DESCRIPTIVE REPORT
(HYDROGRAPHIC)

Type of Survey HYDROGRAPHIC
Field No. LA-10-3-74
Office No..... H-9537

State OHIO
General Locality LAKE ERIE (SOUTH SHORE)
Locality APPROACHES TO FAIRPORT HARBOR

SUBJECT: Quality Control Report for H-9537 (1974), Ohio, Lake Erie
(South Shore), Approaches to Fairport Harbor

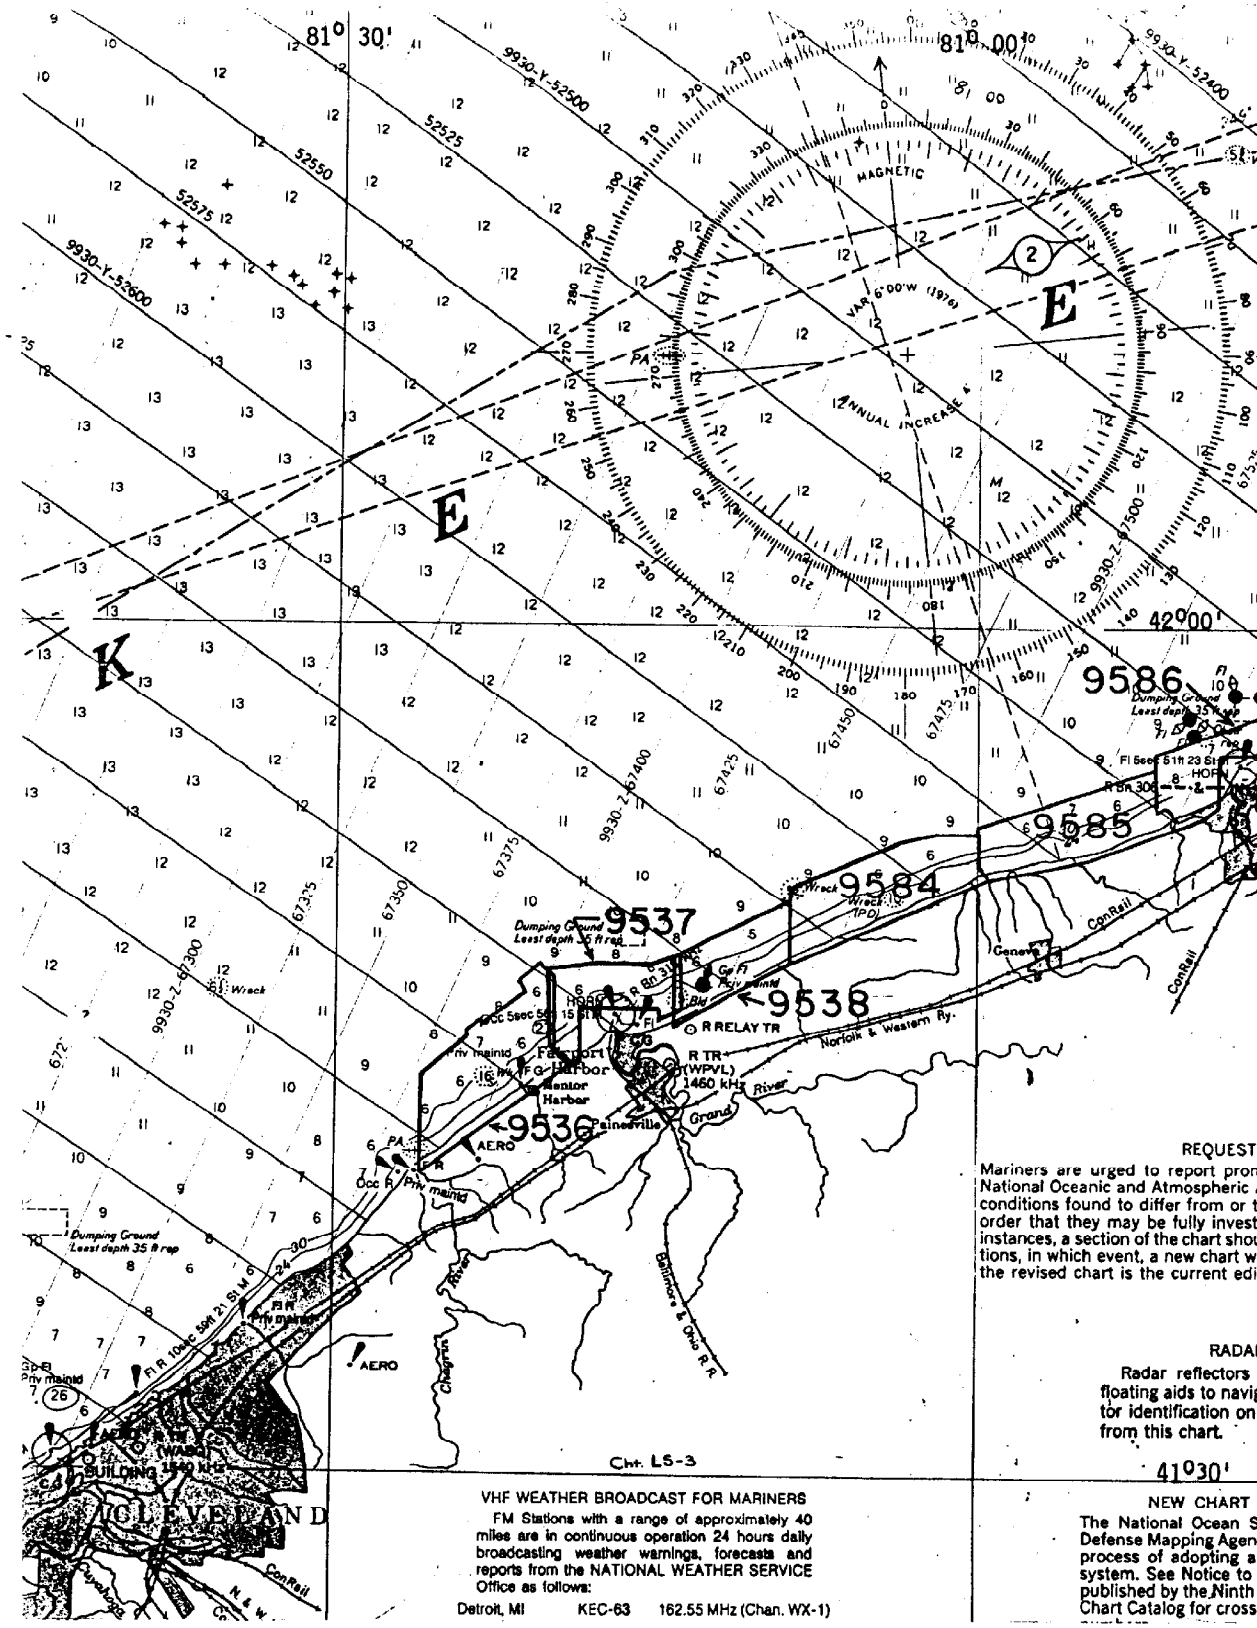
7. The automated title block on hydrographic surveys of the various Great Lakes should include a reference to the IGLD (International Great Lakes Datum) of 1955 followed by the reference elevation for the particular lake. The sounding datum section of the title block for surveys of Lake Erie should read as follows:

Low Water Datum* (IGLD 1955 : 568.6 feet)

The present smooth sheet title block was appropriately revised during the quality control inspection. *(See section 1.5.4.1 of the Hydrographic Manual--Fourth Edition.)
